5/1/72

ERRATA SHEET FOR MODEL S540-T ASSEMBLY INSTRUCTIONS

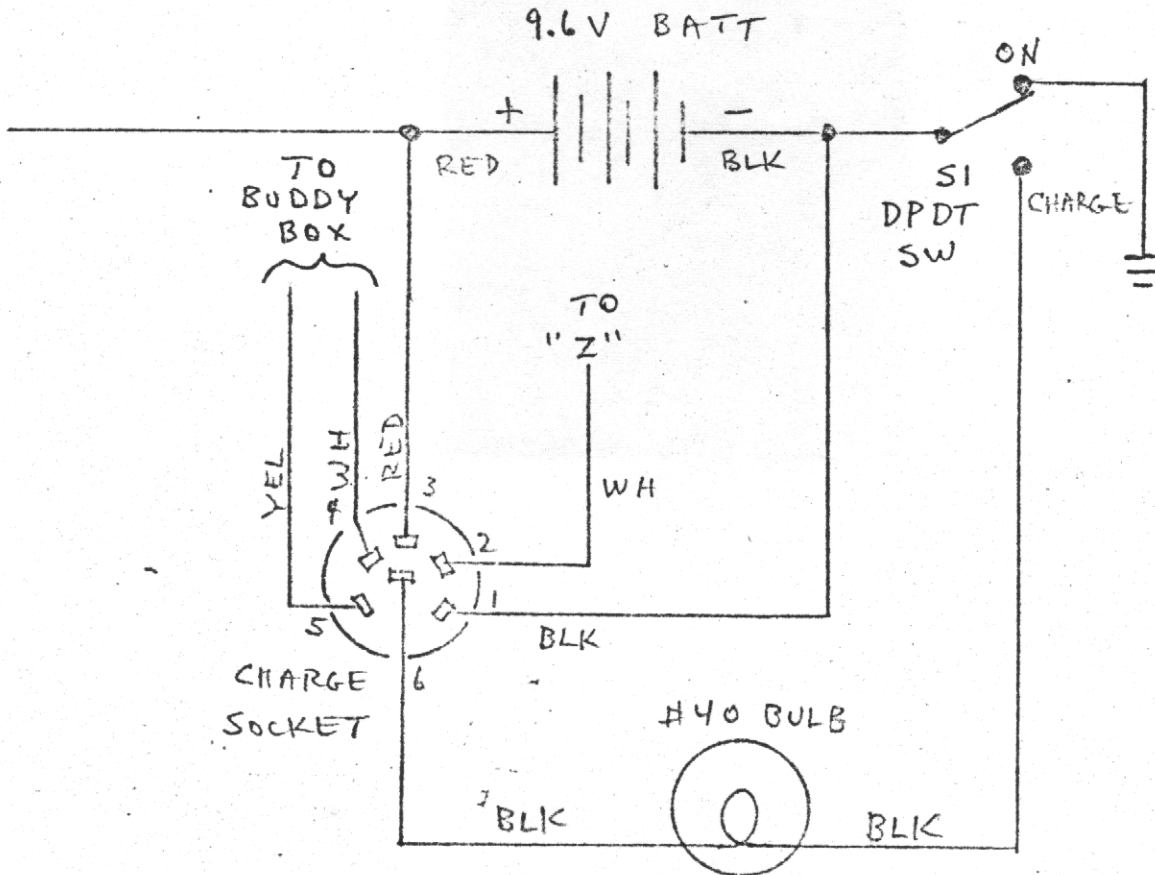
7. Sticks now supplied with this Tx have new style pots which gives them a different physical appearance. All connections are the same as shown in the manual.
8. Install 2N3565 transistors in place of all 2N5134 transistors.
9. In the event your transmitter is to be used with an external charger, omit charging resistor R36, diode CR16 and the AC charge receptacle. Wire as shown below:

Install a cover plate over the square opening for the AC charge receptacle.
